SUPPLEMENTAL TYPE A WATER LICENCE TECHNICAL COMMENT RESPONSES

April 2018
NWB File No. 2AM-BRP----

The **BACK RIVER** PROJECT

Technical Comment Responses Kitikmeot Inuit Association

Figure A-34. Goose Property Culverts Catchments

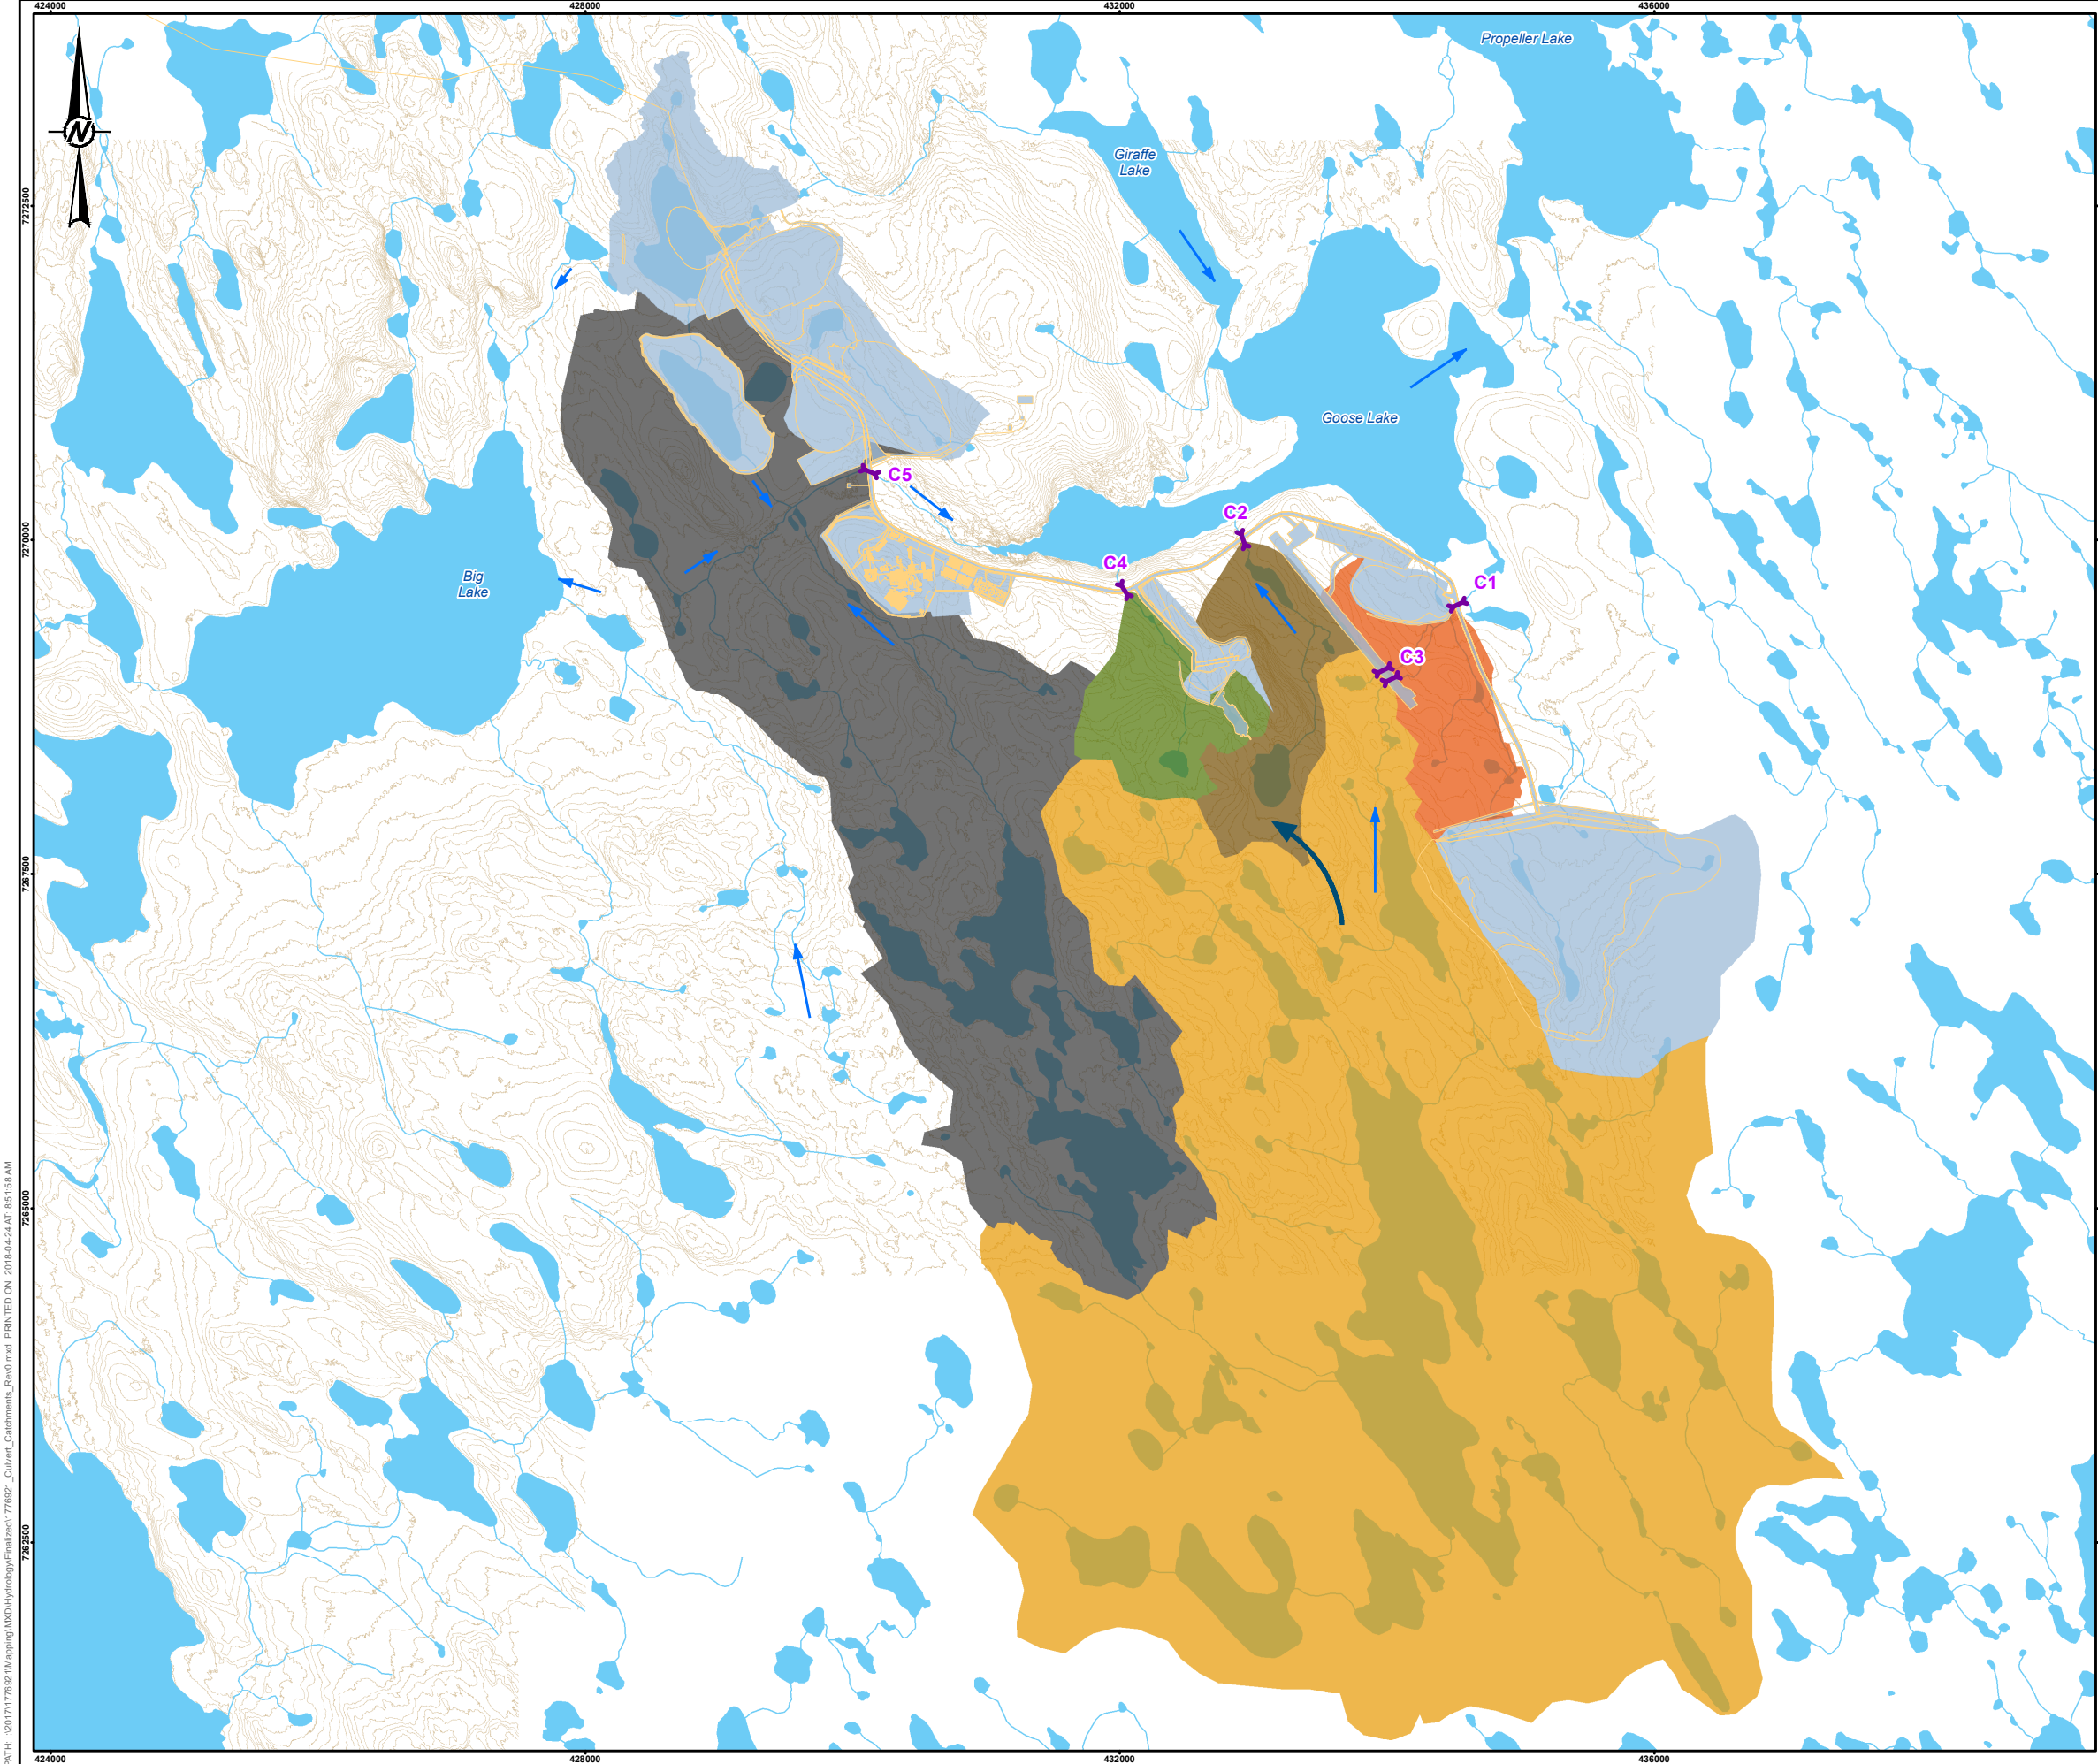
Water Management Plan Figure A-01, Goose Property Catchments, shows proposed culverts but corresponding catchment areas are not delineated.

1. INAC requests that Water Management Plan Figure A-01 be amended or supplemented to show watershed areas draining to proposed culverts.
2. INAC requests clarification on whether conveyance capacity criteria for diversions and culverts is intended to be based on a peak flow (discharge) rate and if the tables showing conveyance capacity in volume units are in error.

1. Sabina acknowledges and agrees with CIRNA's request to update Figure A-01 of the Water Management Plan (WMP; 171005 2AM-BRP----SD05-WaterMgmtPlan_IMLE) to show watershed areas draining to proposed culverts. Sabina will provide the amended figure prior to the Technical Meeting.
2. Sabina acknowledges an error in the units of measure for the conveyance capacity of the diversion berms and culverts. Diversion berms and culverts are designed to convey peak flows generated during the 24-hour duration design event. The amended tables 6.2-3 and 6.2-4 are provided below, and will be included in the next revision of the Water Management Plan. As stated in the Water Management Plan, Sabina will initiate update to the plan prior to start of construction and will incorporate issue for construction engineering drawings of associated water management infrastructure.

1. Sabina stated that an amended Figure A-01 of the Water Management Plan (171005 2AM-BRP----SD05-WaterMgmtPlan_IMLE) to show watershed areas draining to proposed culverts would be provided prior to the Technical Meeting. For clarity purposes, Sabina elected to not update Figure A-01, but instead provide an entirely new figure with the requested information; please see the attached Figure A-34). This figure will be included in the next revision of the Water Management Plan.
